**DATE MAILED: 12/16/2005**

APPLICATION NO.	F	FILING DATE	FIRST NAMED INVENTOR	ATTORNEY DOCKET NO.	CONFIRMATION NO.
10/696,958 10/30/2003		10/30/2003	James Patrick Clinch	140/40303A	8485
279	7590 12/16/2005			EXAMINER	
TREXLER	, BUSH	NELL, GIANGIO	MITCHELL, KATHERINE W		
BLACKST	ONE & M	ARR, LTD.			
105 WEST	ADAMS S	STREET	ART UNIT	PAPER NUMBER	
SUITE 360	0		3677		
CHICAGO.	IL 6060	)3

#### **DETAILED ACTION**

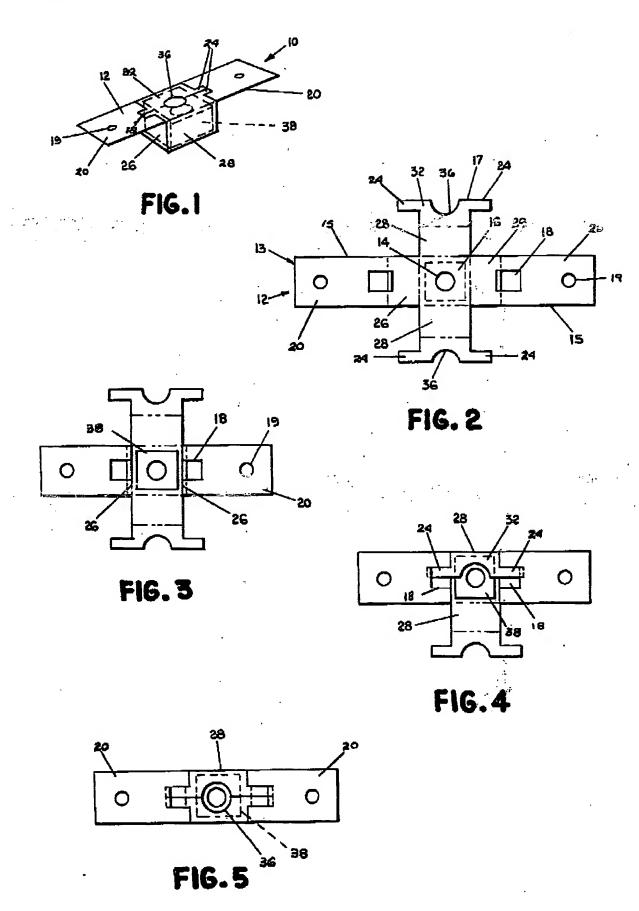
Re claims 1- 3, 6-9, 21,23, 27-32, 34-39, and 43-46: Anderson teaches a cage member (Fig 1, see 12) engageable with a nut 38 having a threaded aperture (col 2 line 57), said cage member capable of encaging the nut (Fig 1) and having an aperture to

allow access to the threaded nut (Fig 1), said cage body having a base portion 16 and 1<sup>st</sup> and 2<sup>nd</sup> arms (28) extending from said base, and a seam (where 17 joins - Figs 1, 2 and 4) defined between 1<sup>st</sup> and 2<sup>nd</sup> arms (see below), at least one of said arm portions having at least one protrusion (tab 24 is considered a half protrusion, and protrudes from arm, two together are considered to form a whole protrusion, and there is a seam therebetween the formed protrusion, see Fig.1) capable of being welded to a mating surface, said seam capable of being provided proximate to a mating surface. Clearly the seam is capable of being near an (unclaimed) mating surface, and the protrusion is capable of being welded to a mating surface. The seam is weldable - both parts are metal. The nut is capable of moving in at least one dimension relative to the base when the nut is encaged. The cage forms a seam (Fig 1 and 5) which is located proximate the mating surface, The fist and 2<sup>nd</sup> arms portions define lower portions of the cage member Fig 1 - orientation is arbitrary). And note that the protrusions 24 protrude from the lower surface (section 32 is shown in Fig 1 as covering 20). There is an aperture configured to allow access to the threaded aperture when the nut is encaged by the cage. The cage and nut members are separately formed and non-integral.
